Docket No. 50-312  
Rancho Seco Nuclear Generating Station  
License No. DPR-54  
**RANCHO SECO HISTORICAL SITE ASSESSMENT, REVISION 1**

Attached is the Rancho Seco Historical Site Assessment (HSA), Revision 1, dated August 2006. The changes include the addition of Section 6.9.5 to address the absence of onsite disposal of radioactive materials, a revision to Figures 4.1, 6.1, and 6.2 to match those used in the LTP submittal, and other editorial corrections.

Sacramento Municipal Utility District  
Rancho Seco Nuclear Generating Station  
Historical Site Assessment

Revision 1  
August 2006

Figure 4.1

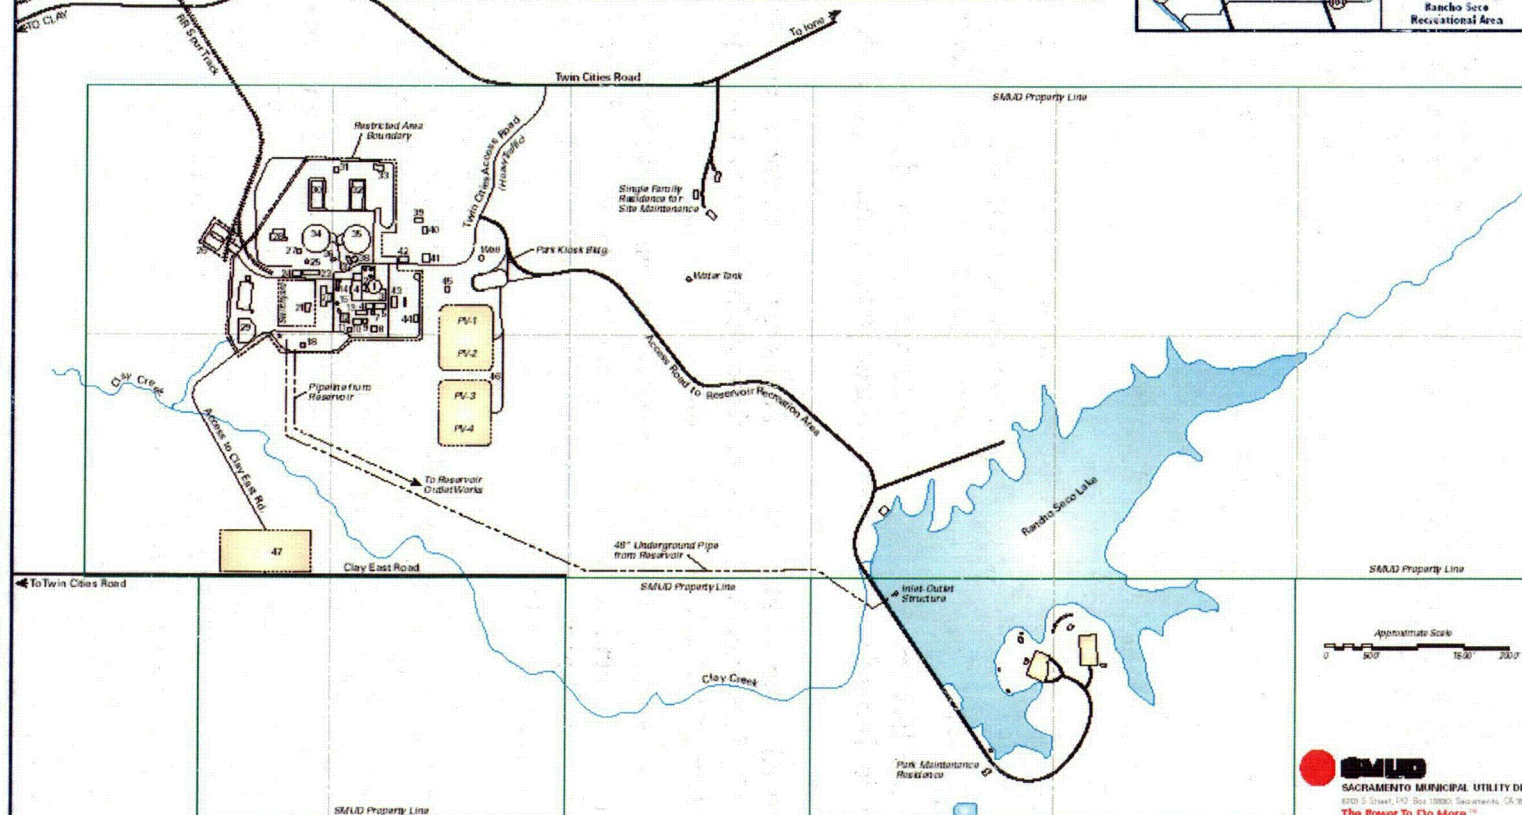
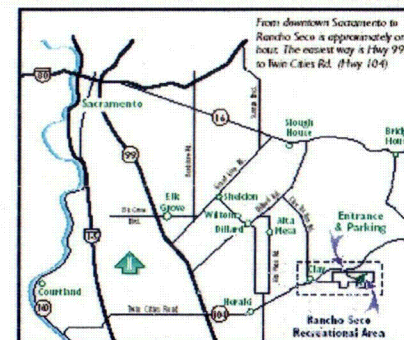
Figures 4.1, 6.1 and 6.2: Revised figures to match those used in the LTP submittal
